A14 Cambridge to Huntingdon improvement scheme

Statement of Common Ground between Highways England and Hilton Parish Council

Date: 28 September 2015

Reference: HE/A14/EX/98/PC11

6 Appendix B – Bridge height requirements

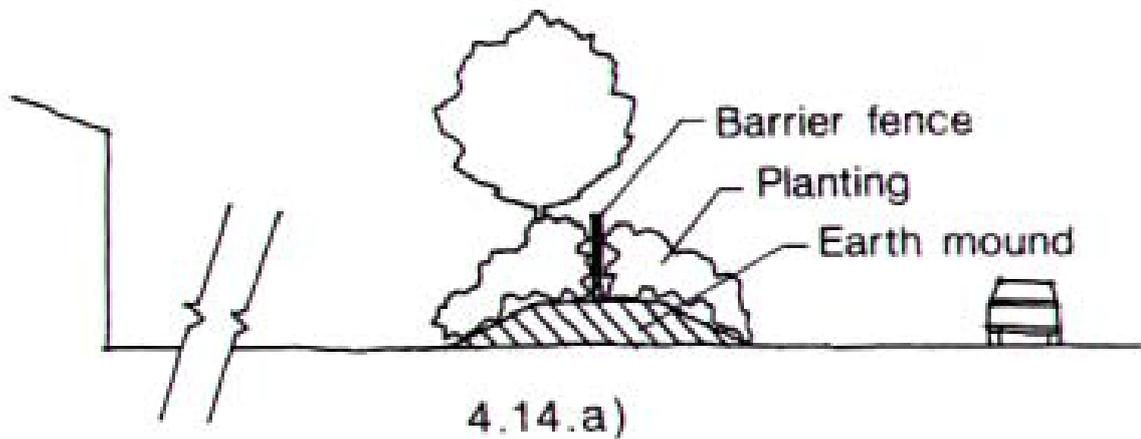
4	Design and Engineering Standards Height of overbridges	Clarification is required on actual height of bridges above existing ground level. The Potton Road and Hilton Road bridges appear to be up to 2	There is scope for refinement at detailed design stage when exact structural options are determined. There will be opportunity for consultation	Under discussion.

<p>metres higher than what is actually required with Potton Road at 11m; and Hilton Road bridge at 10.7m. More detailed engineering drawings are required and engagement at the detailed design stage.</p> <p>Highways England subsequently stated the additional height is due to the single span of the bridge across all six lanes with no central support.</p>	<p>and engagement during detailed design stage, at which stage there will be opportunities to comment on designs.</p> <p>At detailed design the elevation of side roads crossings will be minimised to reduce both impacts and costs. Please refer to Appendix B.</p> <p>In the meantime we will continue to discuss the height and appearance of structures with you.</p>	
5	Landscape and visual effects	<p>Concerns regarding the visual impact and appearance of structures along the route.</p> <p>Hilton Parish Council request to get the best mitigation possible for the people of Hilton.</p> <p>Hilton Parish Council also questions the rules and guidelines which Highways England contractors will have to work to.</p> <p>Hilton Parish Council are concerned about the impact of light pollution from high sided vehicles hence the wish for a higher barrier up to 4m in height.</p>	<p>In view of the concerns raised about visual impacts as the road passes Hilton (in particular relating to the Potton Road over bridge), a desk study has been undertaken to identify a proposed additional and representative viewpoint on the north edge of the village which places the overbridge clearly in view without intervening screening. It is to show the proposed scheme and the Potton Road bridge before construction and at year 1 and year 15 after construction.</p> <p>This viewpoint was shared with Hilton Parish Council and a site meeting was held with the Parish Council on 3 June 2015 to assess the suitability of this and potential alternative viewpoints suggested by the Parish Council. The Parish Council concurred that Highways England's proposed viewpoint is suitable for an additional photomontage.</p> <p>The photomontages from the agreed viewpoint can be found within Highways England's Response to the First Written Questions</p>	Under discussion.

As set out in Highways England’s response to the First Written Questions, Question 1.9.9, the majority of the new bridge structures on the scheme, including those on the Huntingdon Southern bypass section, are similar in nature and have been developed as a family of structures known as the ‘Standard Overbridges’.

The typical height of an overbridge is 11.2 metres above ground level, this height is a summation of the following requirements:

1. The height of the mainline above ground level is driven by drainage requirements;
2. A 5.3 - 5.7 metre headroom is required under the bridge to accord with design standards (this depends on the structures impact resistance, so the scheme uses 5.7 metre structure to keep structure options open);
3. A structural depth of 2.0 metres is typically required (dependent upon the structure type and span);
4. Allowance for construction on bridge;
5. Allowances for road crossfall, gradient, construction and settlement etc.

- $3\text{m} + 5.7\text{m} + 2\text{m} + 0.5\text{m} = 11.2\text{ metres above ground level.}$
